Our ref: 11014-ltr-008
Date: 8th December 2017

RE: Birdwood Park RSL LifeCare Development
No.510 King Street., Newcastle West 2300
DA 2016/00654
SUMMARY of SECT.96 REVISIONS

Please find following below, a summary of the key 'major' & 'minor' revisions, forming the Section 96 submission, to the approved DA.

APPENDIX 1 – GROUND LEVEL FLOOR PLAN COMPARISONS

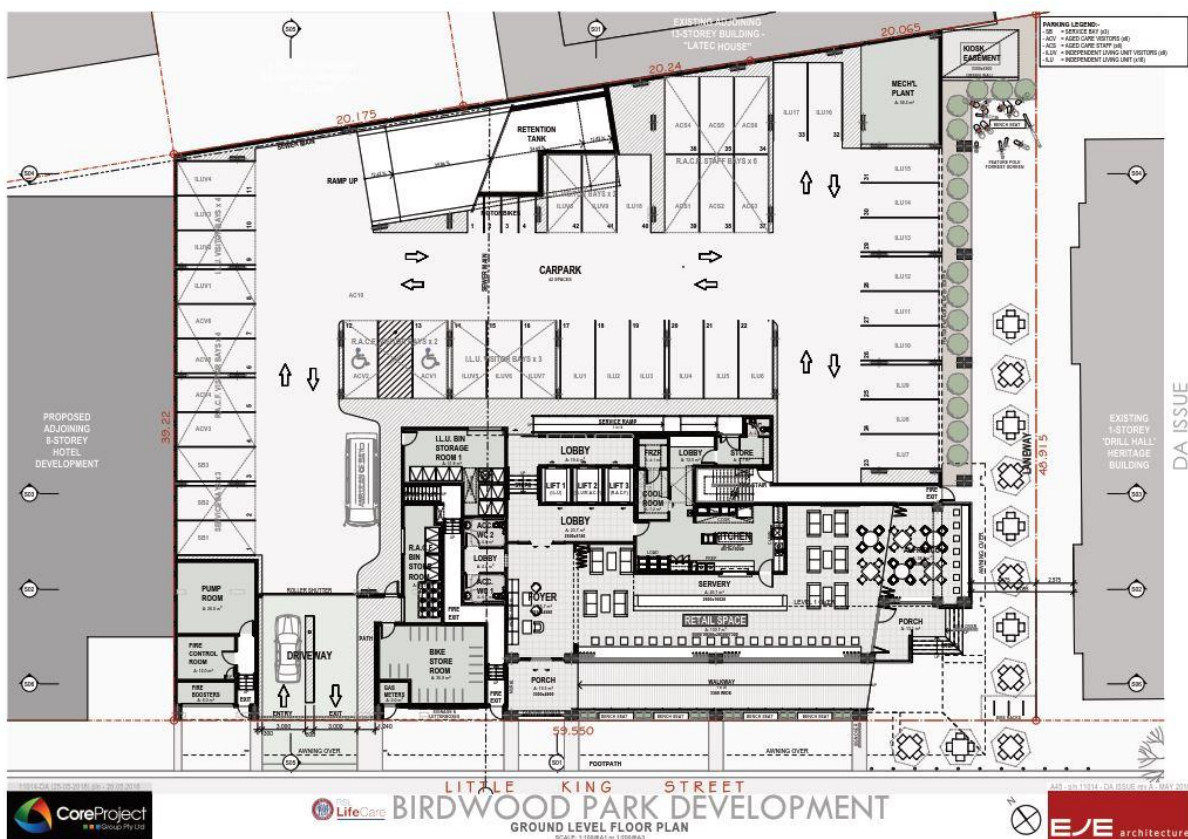
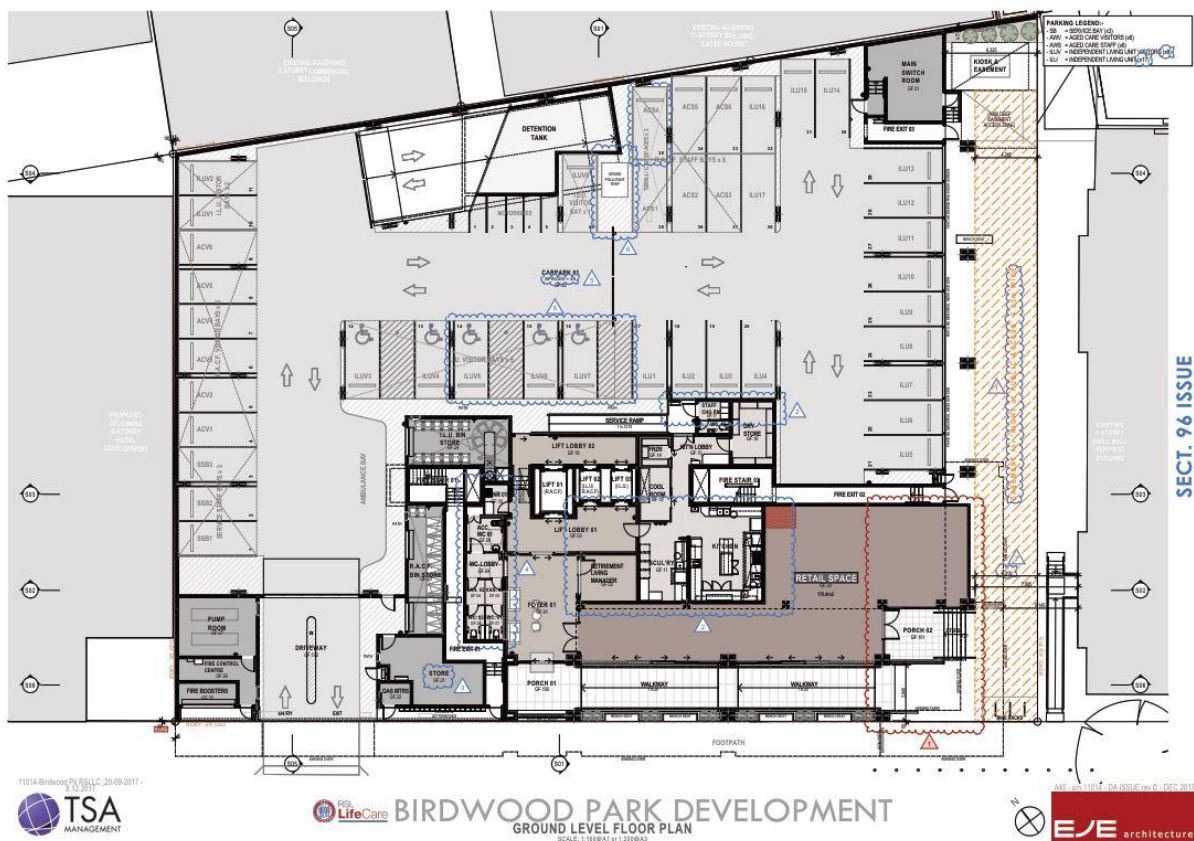
- **1** – Alfresco area enclosed as part of internal Retail Space; & Porch, steps, & column alignment revised, & an easement for 'Right of Public Access' shown as per DA Cond. # 89;
- **2** – Retail Space & Kitchen layouts revised, & Manager's Office added;
- **3** – Bike Store revised to Store only;
- **4** – Public amenity layouts revised;
- **5** – no. of car spaces in total revised from 42 to 41;
- **6** – parking spaces/bays revised (3 additional 'accessible' spaces, as per DA Condition #6);
- **7** – minor boundary setback revision (*note:- due to minor survey discrepancy [i.e. boundary angle twist] & resultant building siting adjustment to suit; & design development of facade construction techniques):-
 - from 4.475m to 4.31m (eastern laneway columns);

APPENDIX 2 –LEVEL 1 FLOOR PLAN COMPARISONS

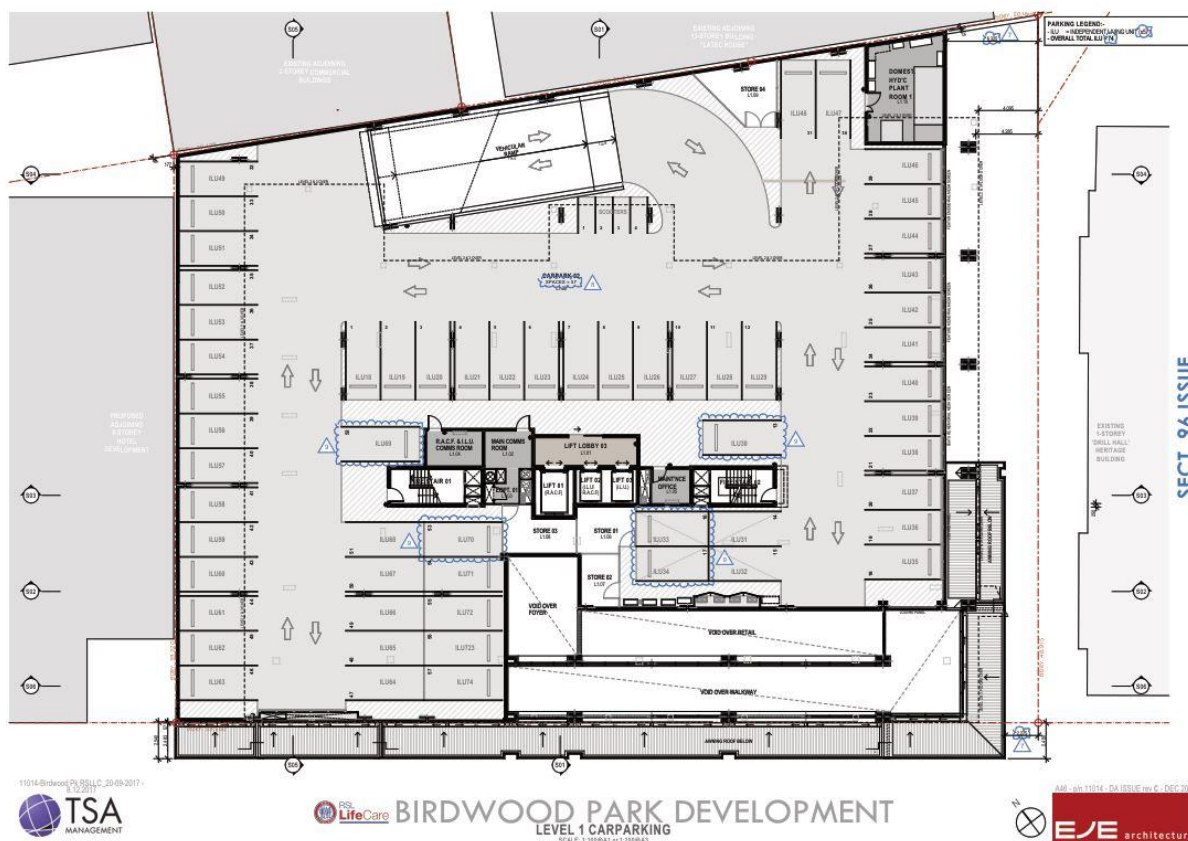
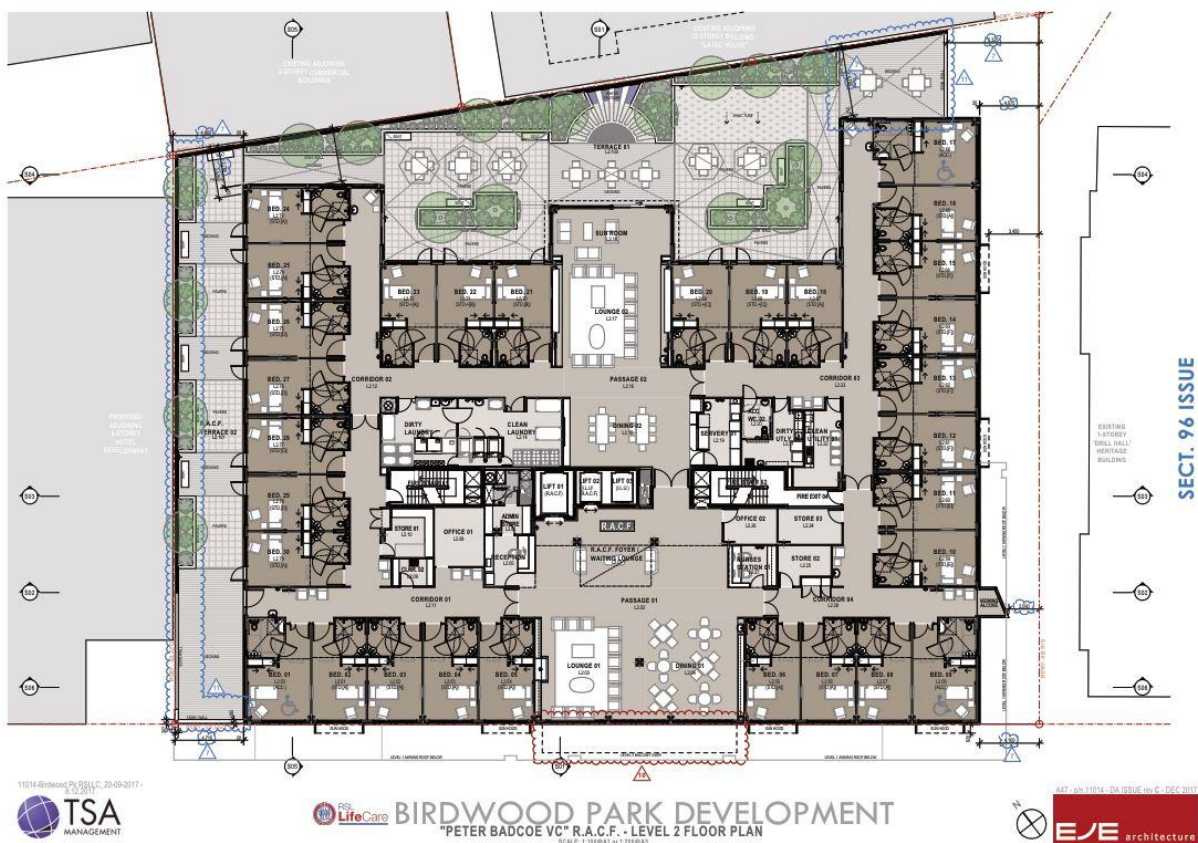
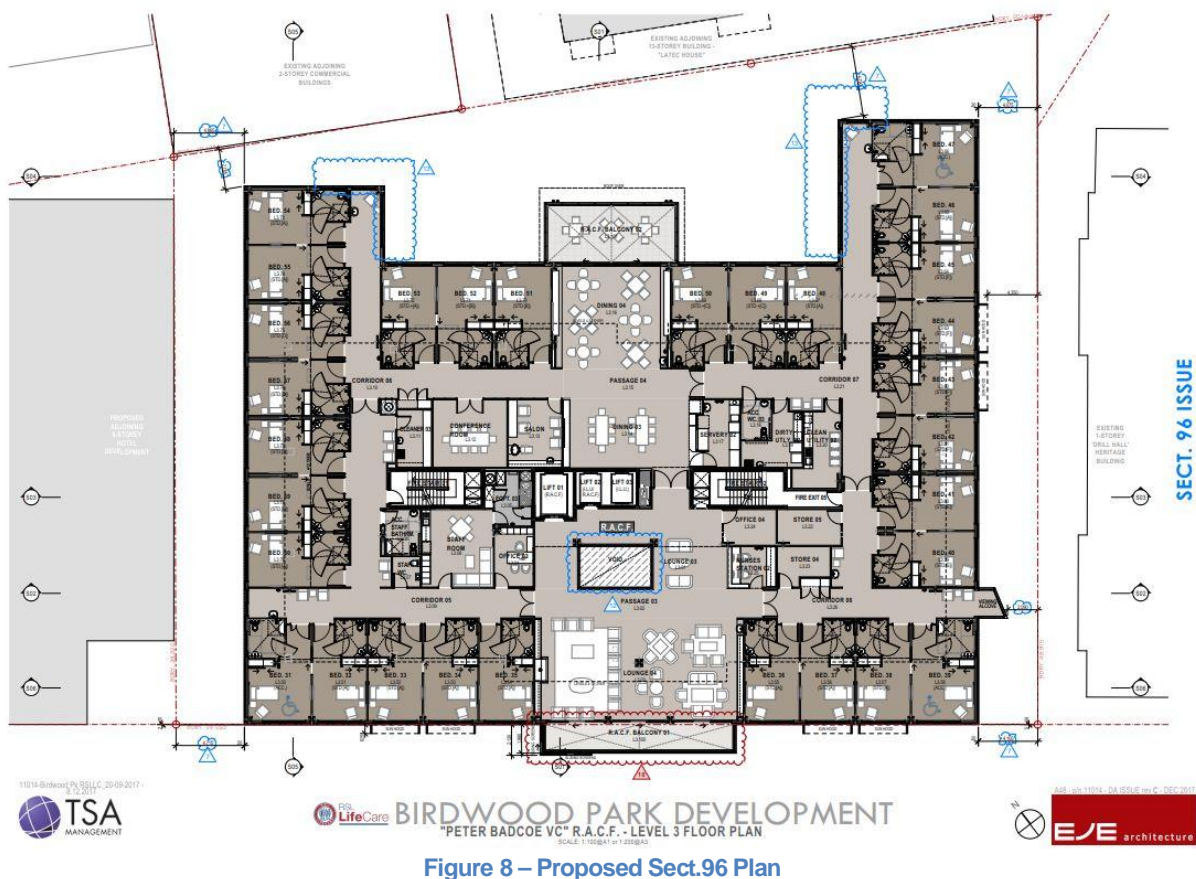
- **7** – laneway awning roof extended towards eastern side boundary (1.16m closer) & minor boundary setback revisions (*note):-
 - from 6.525m to 6.325m at NE corner to east;
 - awning roof from 3.425m to 2.275m to east;
- **8** – no. of car spaces in total revised from 52 to 57;
- **9** – parking spaces/bays revised (5 additional spaces);

APPENDIX 5 – LEVEL 4 FLOOR PLAN COMPARISONS

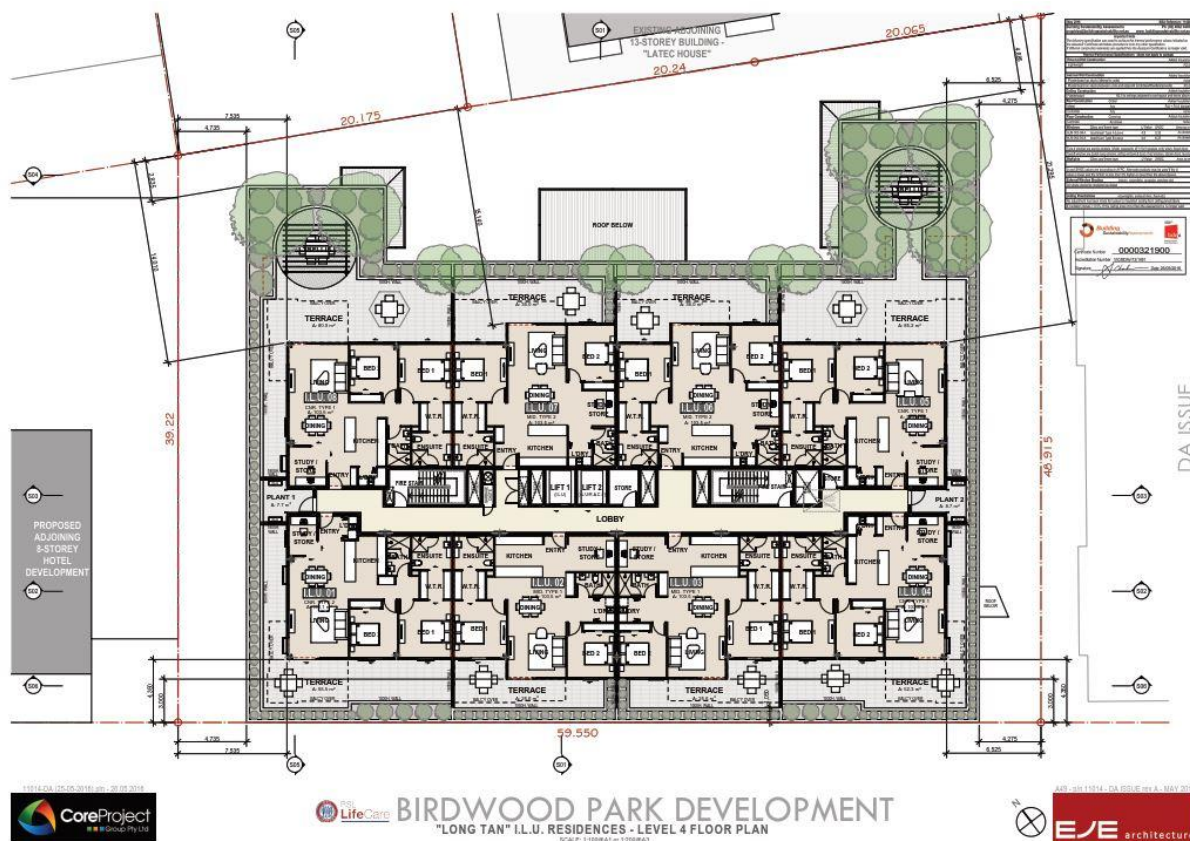
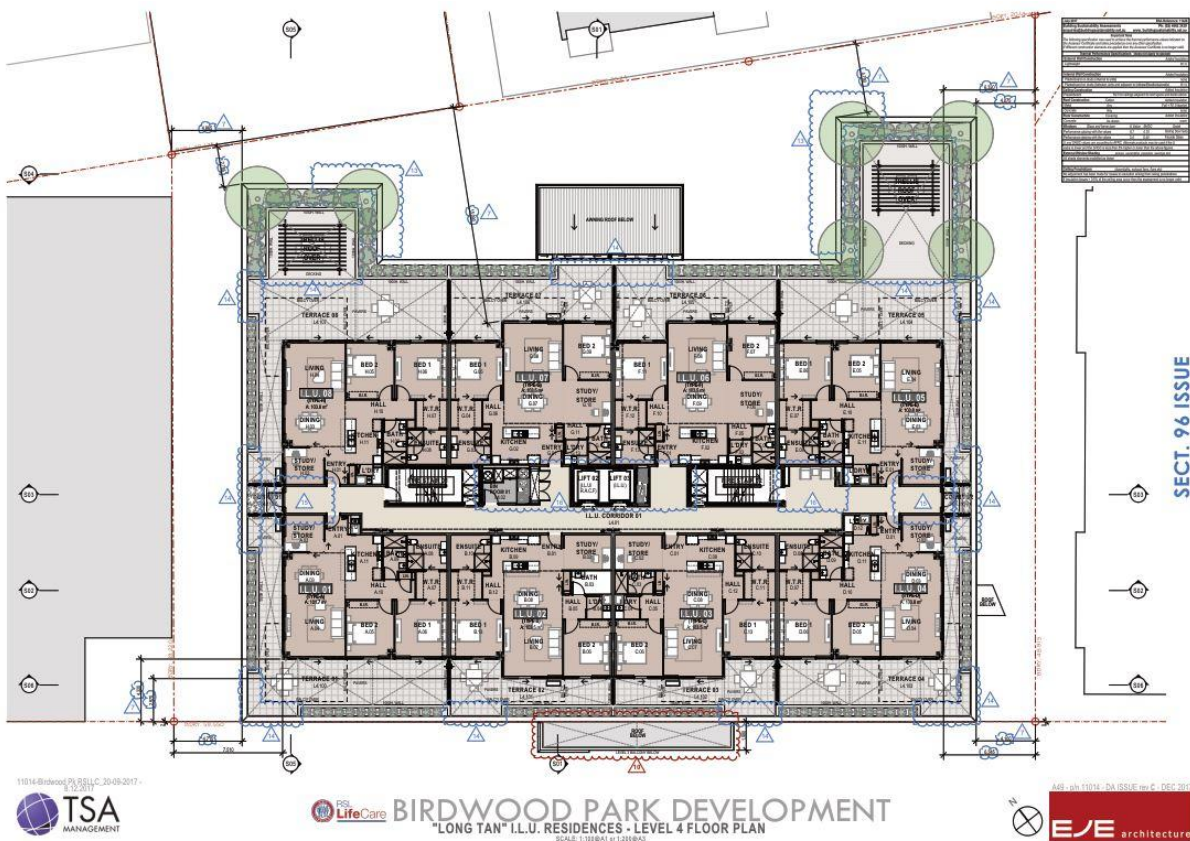
- 7 – minor boundary setback revisions (*note):-
 - at NE corner:-
 - § from 6.525m to 6.320m for ILU facade to east;
 - § from 4.275m to 4.075m for terrace to east; &

- § from 4.885m to 4.79m for terrace to north;
 - at SE corner :-
 - § from 4.275m to 4.1m for terrace to east; &
 - § from 6.525m to 6.345m for ILU facade to east;

- at SW corner:-
 - § from 4.735m to 4.715m for terrace to west; &
 - § 7.535m to 7.510m for ILU facade to west;
 - at NW corner:-
 - § from 4.735m to 4.865m for terrace to west; &

- § 2.835m to 2.785m for terrace to north;
- 13 – rear cantilevered awning roofs over level below removed;
- 14 – external terrace landscaping planters revised/simplified/rationalised (to also allow for over-flow drainage spitters through the perimeter walls);

- 15 – external alcove space at ends of public corridors enclosed & public corridors extended into;
- 16 – internal core layout of Lifts, Lobbies, Bin Room, service riser shafts revised;
